• **FINAL PLAT OF** •
• **STONEHEDGE SECOND ADDITION** •
• **AN ADDITION TO WICHITA, SEDGWICK COUNTY, KANSAS** •

Re.: S/D 84-113 - Final Plat of Stonehedge 2nd Addition

Final Plat
SUBDIVISION REPORT
S/D 84-II3 - STONEHEDGE 2ND ADDITION

S/D No.: 84-113 Name: STONEHEDGE 2ND ADDITION

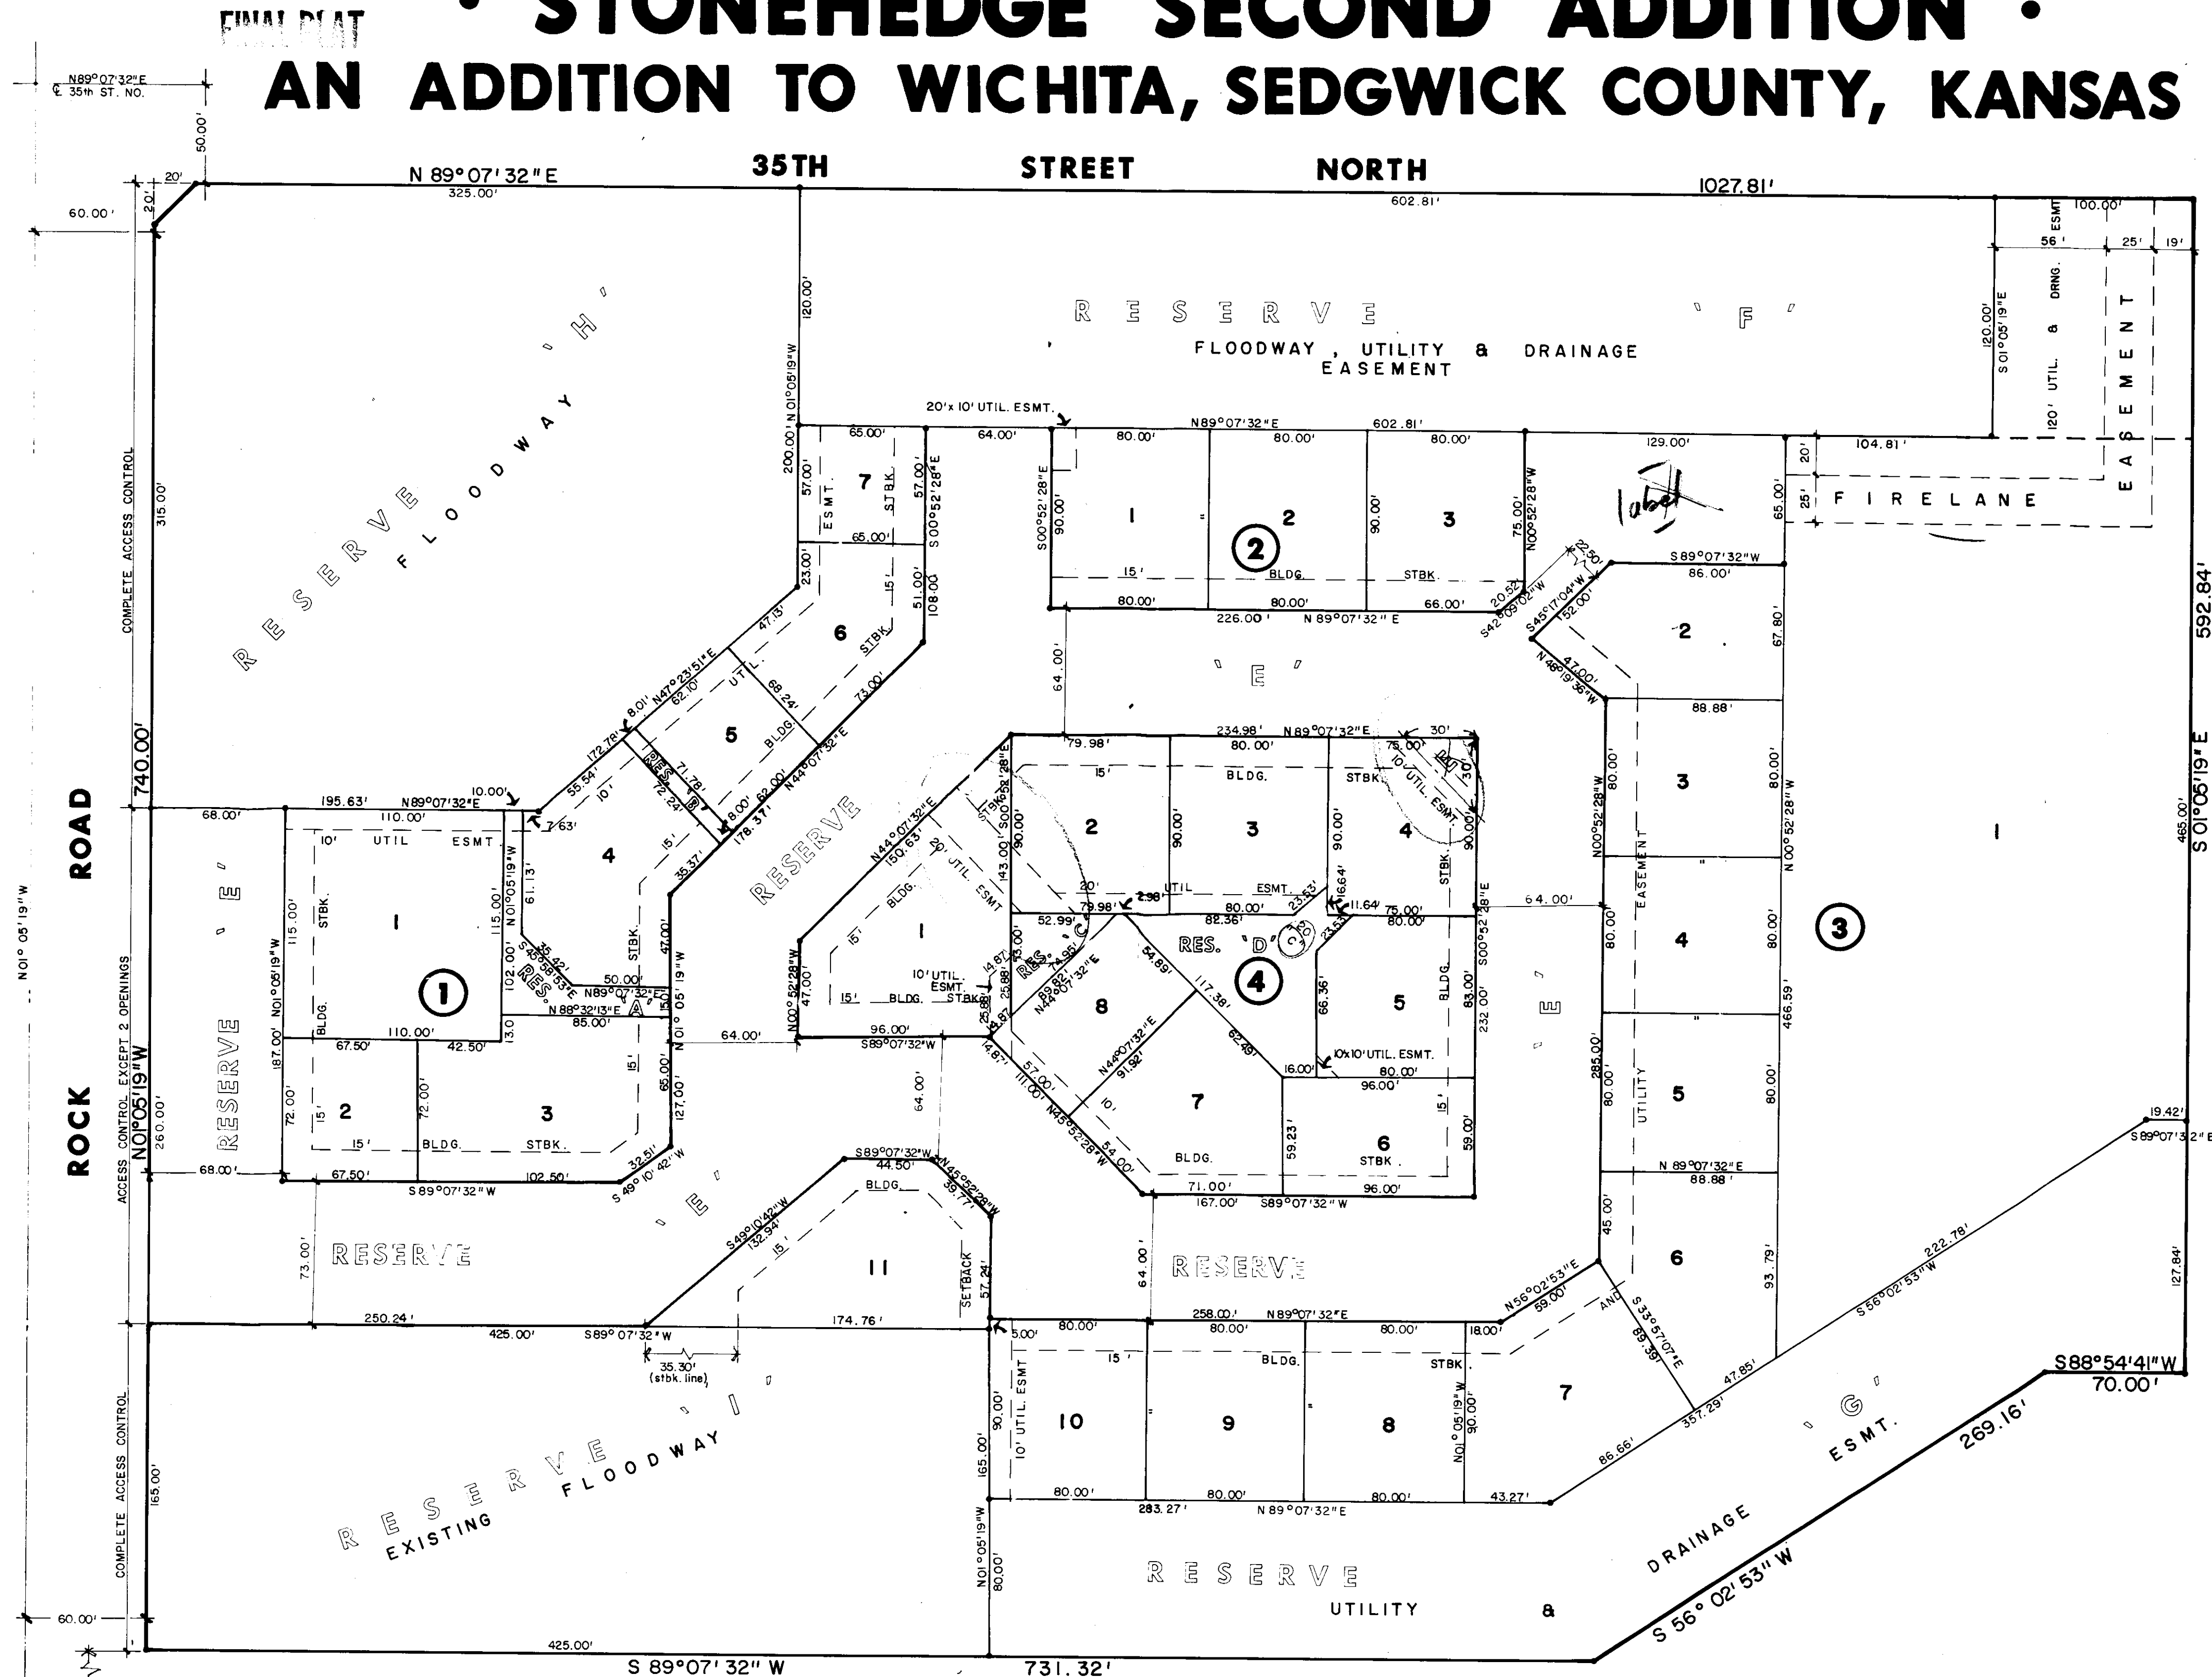
- L. On the final plat tracing, the center line of the 10-foot utility easement at the northeast corner of Lot 4, Block 4 shall be labeled.
- M. On the final plat tracing, the 20-foot utility easement, at the northeast corner of Lot 1, Block 4 and the southwest corner of Lot 2, Block 4, shall be dimensioned from lot lines.

- N. On the final plat tracing, ED RESA shall be indicated as Deputy to the Register of Deeds.
- O. On the final plat tracing, the signature block of the County Commissioners shall be corrected to reference the following order of signatures:

1. DONALD E. GRAGG
 2. BERNARD A. HENTZEN
 3. TOM SCOTT
- P. On the final plat tracing, the platlor's text shall be amended to reference the platting of Reserve "B."

- Q. On the final plat tracing, the area north of Lot 2, Block 3 and east of Lot 3, Block 2 shall be labeled.
- R. Closure computations shall be submitted with the final plat tracing.

- U. The applicant, or his agent, shall be prepared to state what the 20 "C" labeling within Reserve "D" means.
- V. The applicant, or his agent, shall be prepared to state what the "E" labeling within Lot 4, Block 4 means. Is this now part of Reserve "E"? If so, why haven't the lot lines been adjusted for Lot 4, Block 4?

- F. As required at the time of preliminary plat approval, this plat shall indicate the boundaries and recording data of the private sewer easement which provides Lot 2, Block 1 with sanitary sewer service. This private easement shall be indicated on the final plat tracing.

- G. On the final plat tracing, the labeling of the utility and drainage easement, adjacent to the north line of Lot 1, Block 3, shall be accompanied by arrows which indicate the boundaries of this easement (i.e., is the easement's east line the west line of the firelane easement or is it the east line of the plat?).

- H. The final plat tracing shall clarify the conflict between the plat's text and the face of the plat regarding the purposes of Reserve "F" (i.e., is this Reserve being platted for floodway purposes or not?).

- I. The required minimum building pad shall be expressed in Mean Sea Level as well as in City Datum.
 - J. Access to all interior lots in Blocks 1 through 3 is to be provided in Reserve "A." The applicant is advised that, at the time of lot development, improvements in Reserve "A" will be required to meet the minimum firelane standard.
